RETREAT AT TIMBERRIDGE FILING NO. 1

CONSTRUCTION DRAWINGS

Engineering Review
05/15/2020 10:27:32 AM
dsdrice
JeffRice@elpasoco.com
(719) 520-7877
EPC Planning & Community
Development Department

SITE MAP
SCALE: 1" = 500'

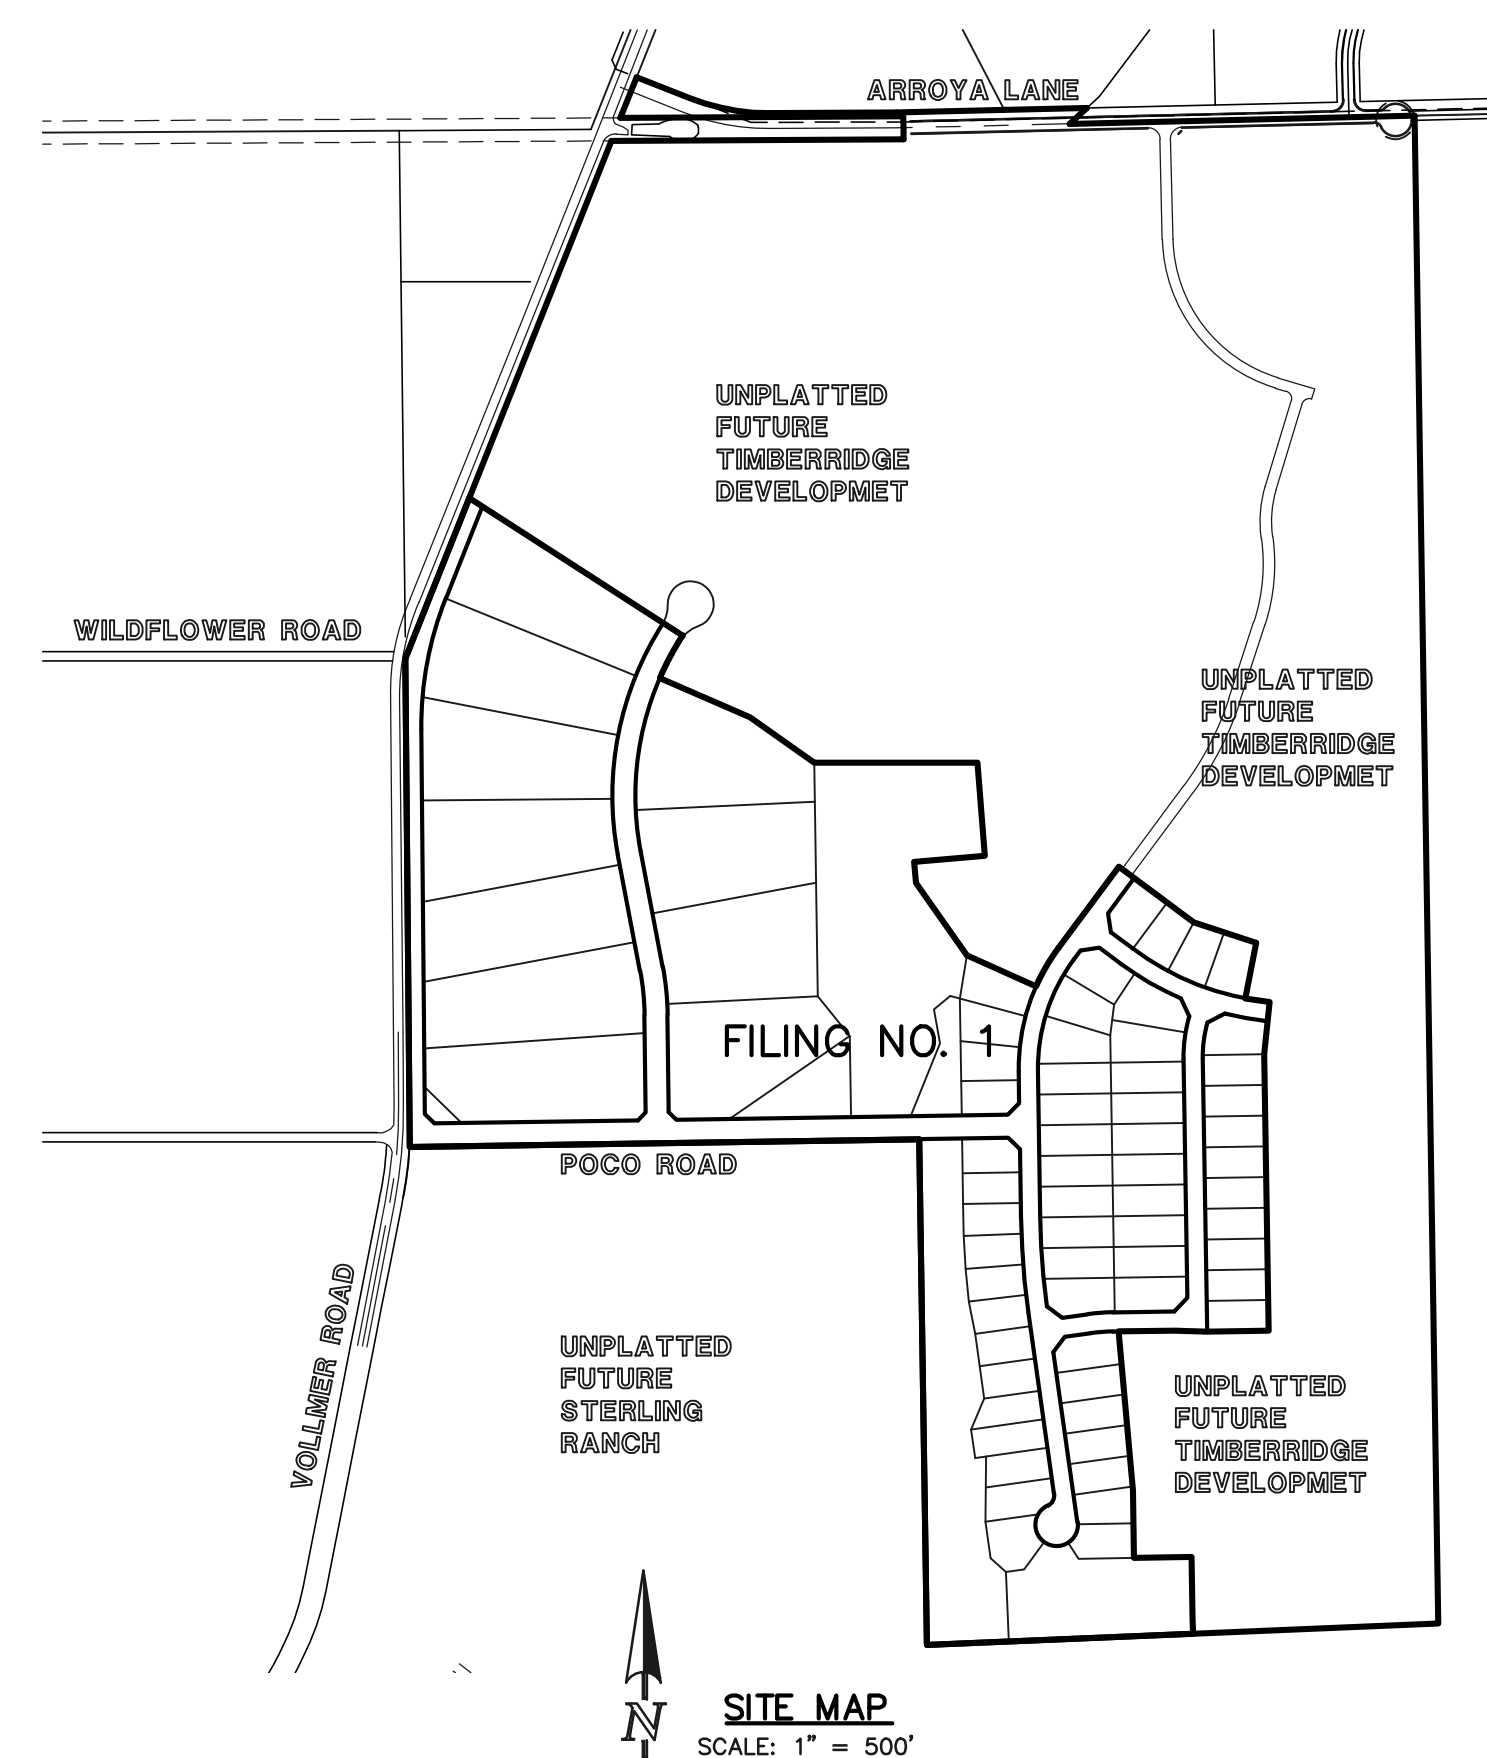
Basis of bearings / control points w/ coordinates?

RETREAT AT TIMBERRIDGE FILING NO. 1			
CONSTRUCTION PLANS			
GRADING & EROSION CONTROL PLAN			
DESIGNED BY	PRA	SCALE	DATE 04-05-19
DRAWN BY	ESO	(H) 1"= 100'	SHEET 8 OF 35
CHECKED BY	(V) 1"= N/A	JOB NO.	1185.00

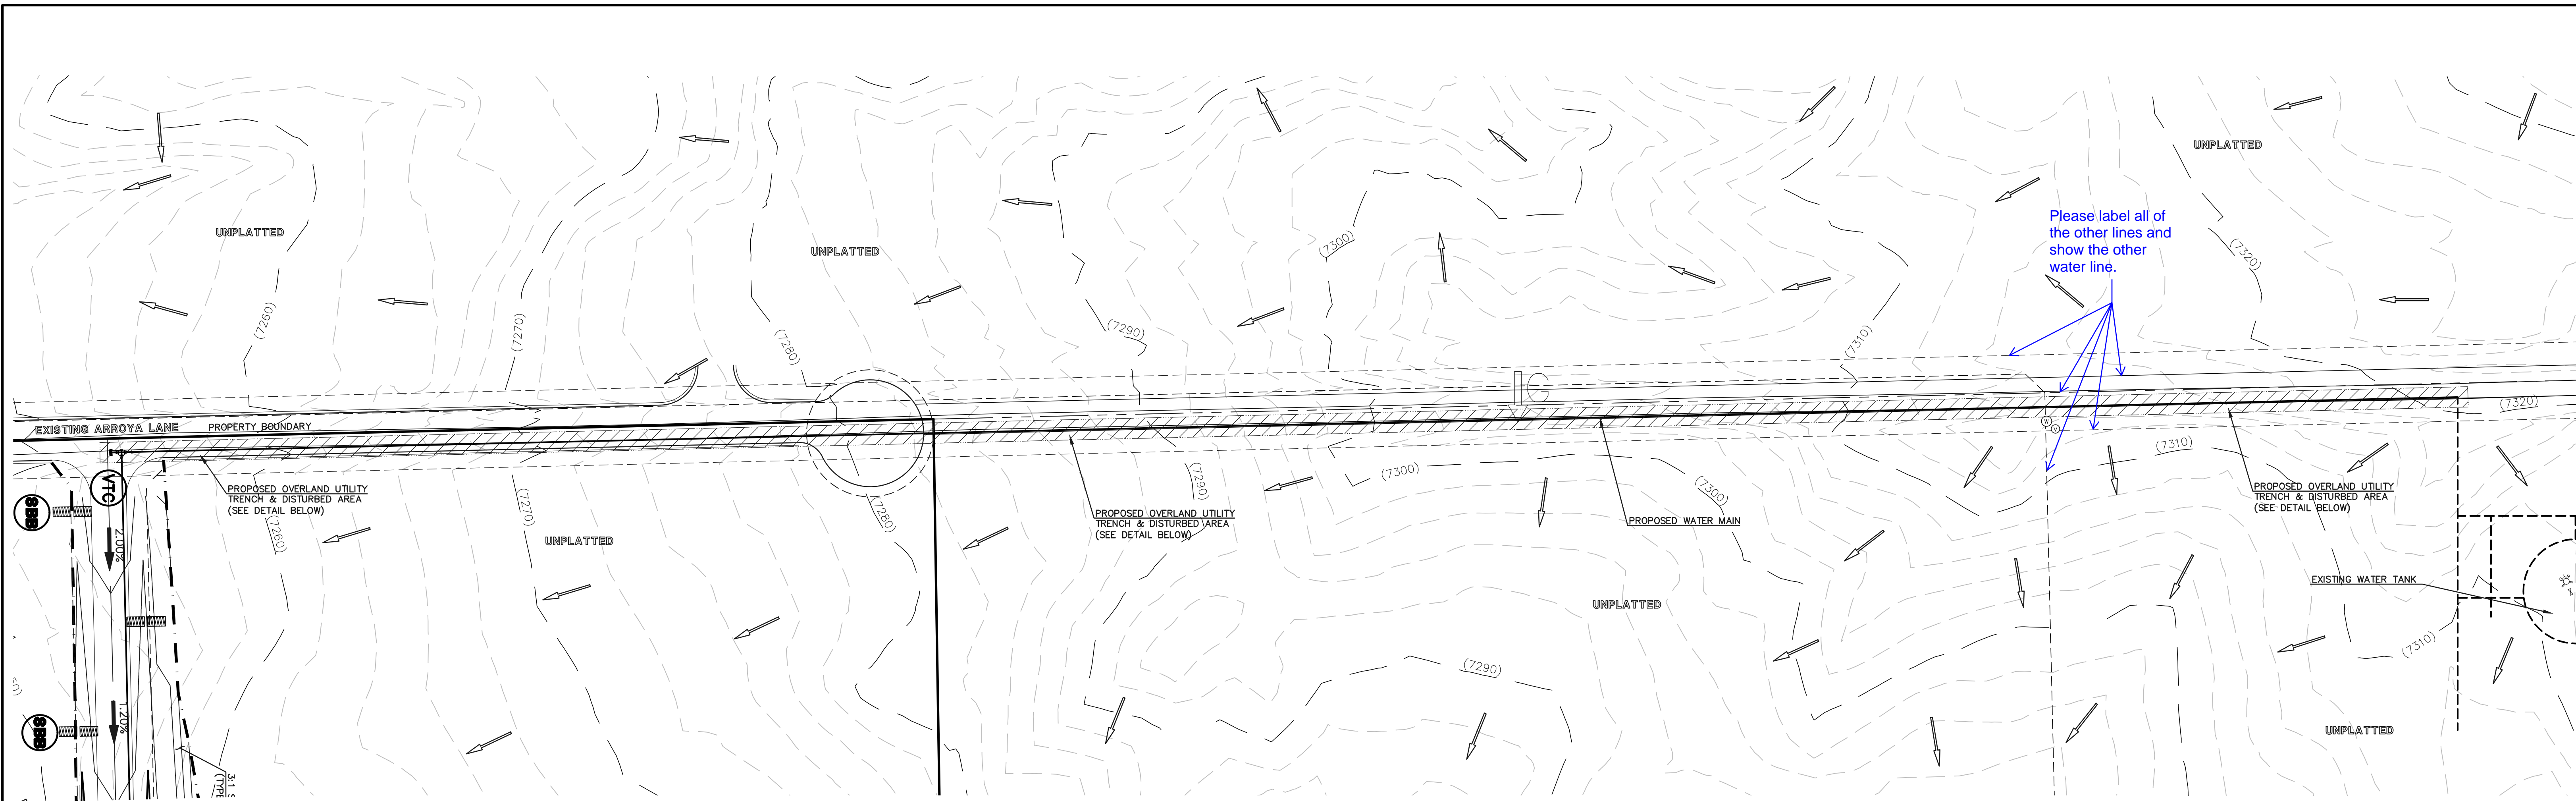
Is there a creek crossing temp BMP/dewatering detail?

RETREAT AT TIMBERIDGE FILING NO. 1
CONSTRUCTION PLANS
STREET IMPROVEMENT PLANS
ANTELOPE RAVINE DR. & HAWK HILL CT.

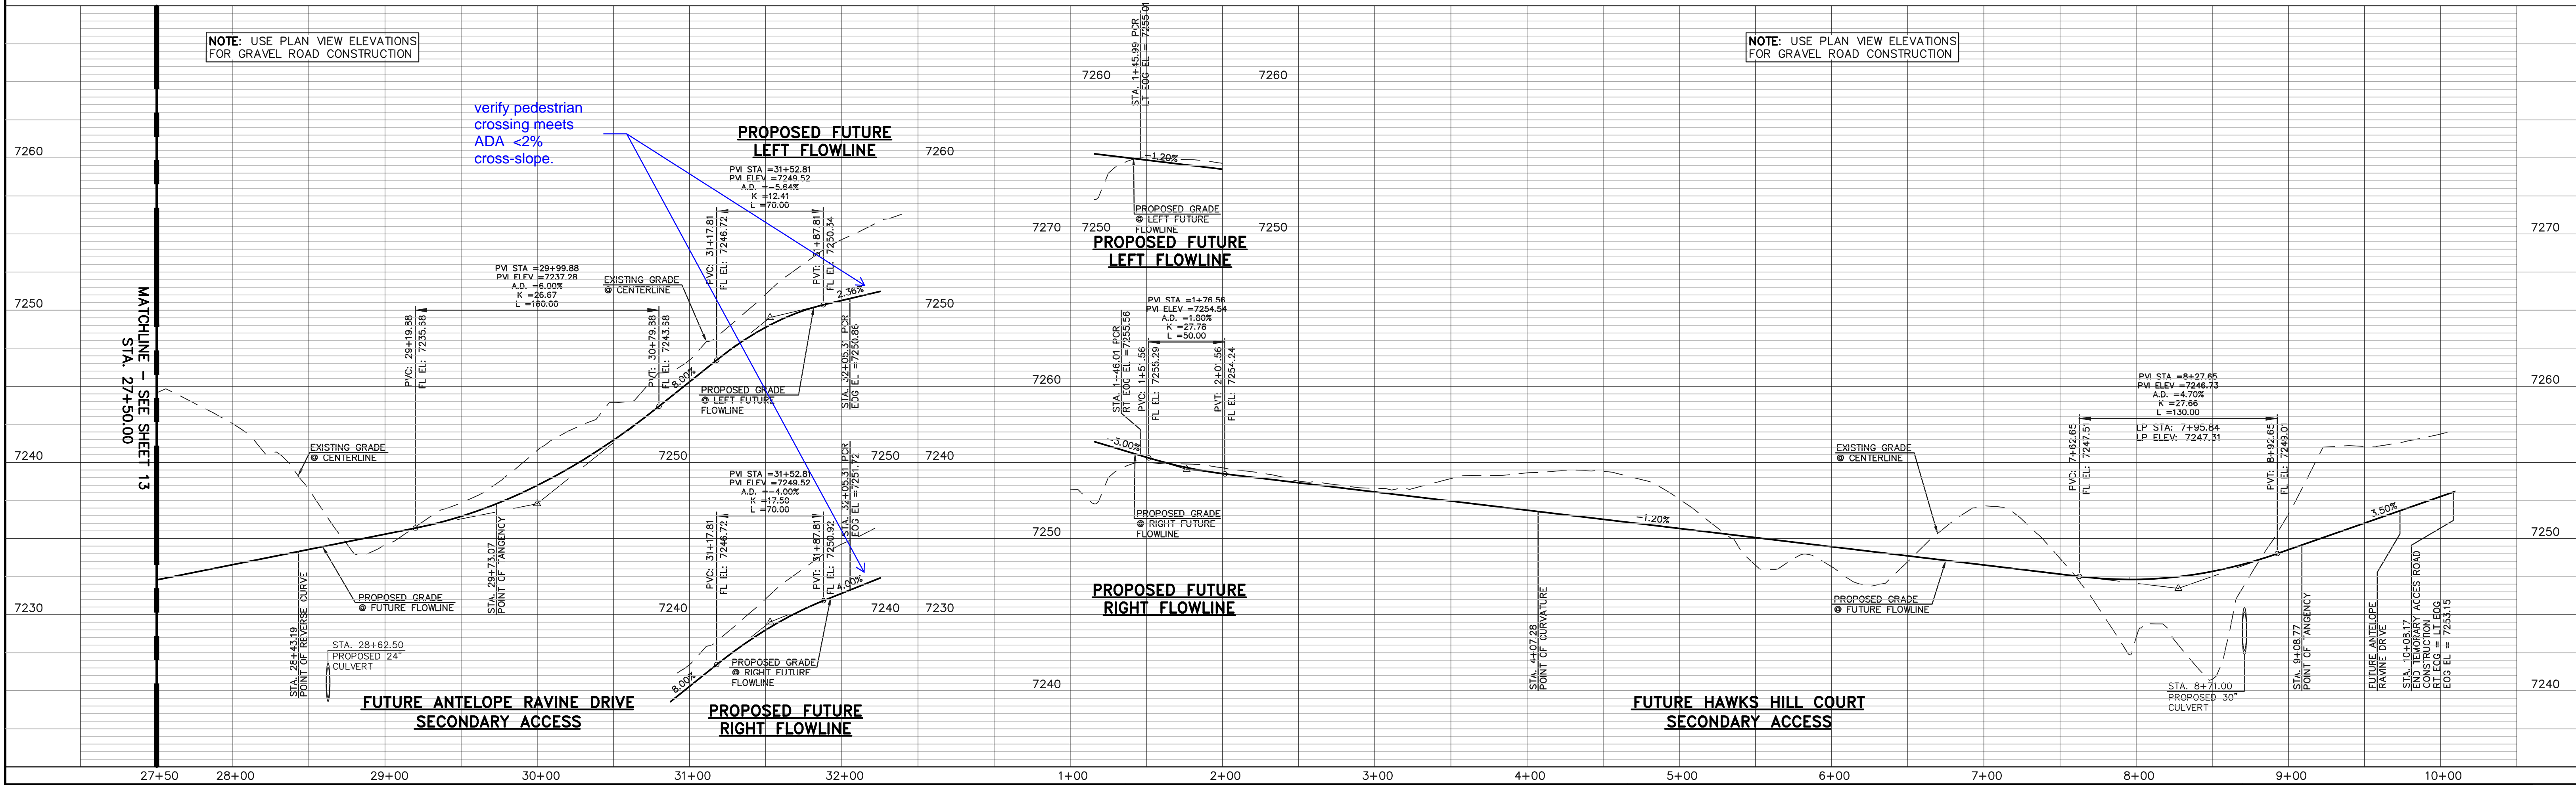
verify pedestrian crossing meets ADA <2% cross-slope.
